PONTIAC

Service Craftsman News

No. 7 S-296

July, 1957

Fig. 3 Safari Rear Seat Back Retainer

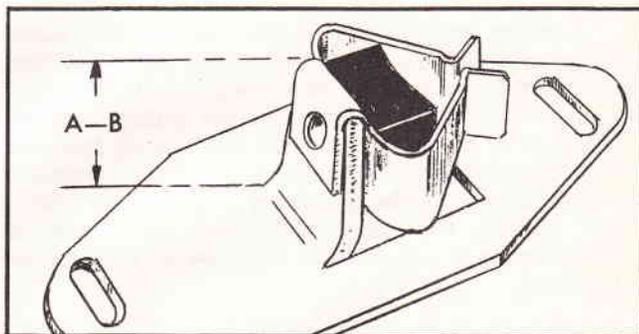
The folding rear seat back on a two seat Safari is held in the "up" position by retainer assemblies on each side of the seat. Production Information Reports have been received stating that these retainers squeak and rattle. Investigation reveals that retainers on early production Safaris were too long (distance A-B, Fig. 3) causing them to rub against the cover.

If this condition is encountered, the retainer should be replaced with a current production part having the correct clip length, 55/64 inch. Lubricate the clip with DC #4 Compound (silicone) or glycerine.

After the new assembly is installed, check to see that there is enough clearance between the retainer and cover to prevent squeaks. Also, see that there is clearance between the stops on the sides of the seat back and the slots in the retainer covers. Retainer assemblies may be ordered under part Number 4650413.

Fig. 4 Fuel Injection Fast Idle Link Adjustment

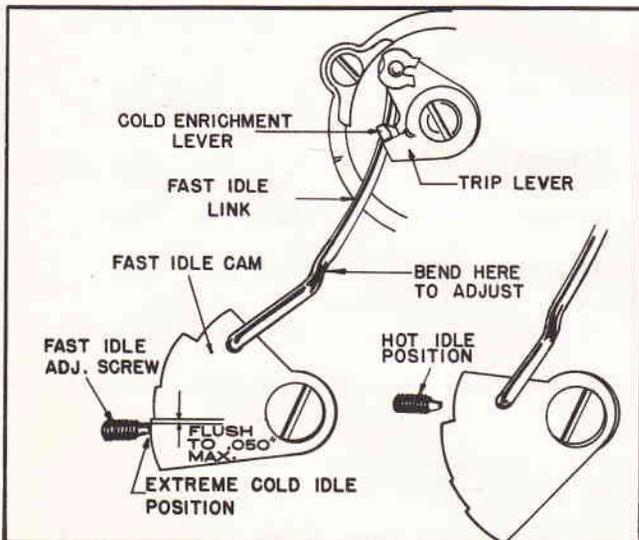
To insure correct functioning of the fast idle system on fuel injection equipped cars the relationship between the fast idle cam and the cold enrichment assembly must be within prescribed limits. This relationship is maintained by the length of the fast idle link and can be checked and adjusted as follows:

1. While holding the throttle valve open manually move the choke trip lever clockwise to its full travel.
2. With trip lever in full clockwise position and in contact with tang on cold enrichment lever, check point at which fast idle adjusting screw contacts cam.
3. As shown in Fig. 4, the screw should be on the high step of the cam and from flush to .050" from the step.
4. Bend link where shown to adjust.
5. After setting on high step, check that with trip lever in full counterclockwise position (hot idle), screw is entirely clear of cam as shown in illustration.

The above information supplements that found in the Fuel Injection manual and it is suggested that reference to this adjustment be incorporated in the manual.

Fig. 5 Corrected Fig. 27 and 55 in Fuel Injection Manual

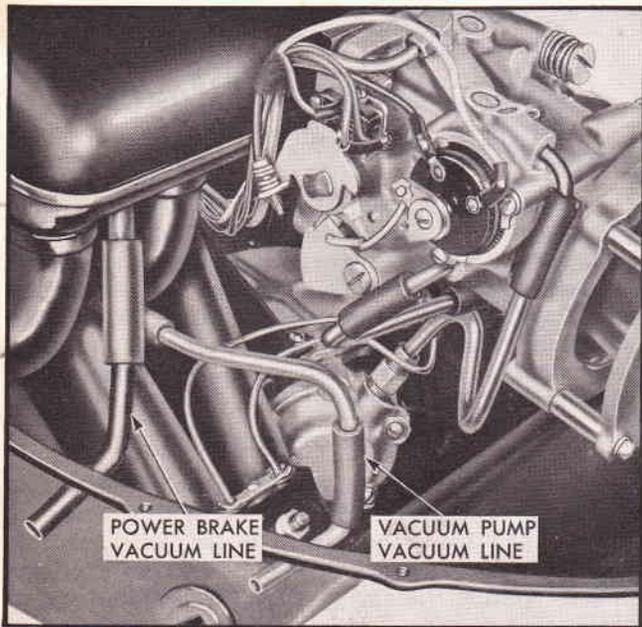
Fig. 27 and 55 show an incorrect location of the signal modifier and enrichment vacuum lines. Fig. 5 is a corrected illustration. Please correct your manuals accordingly.
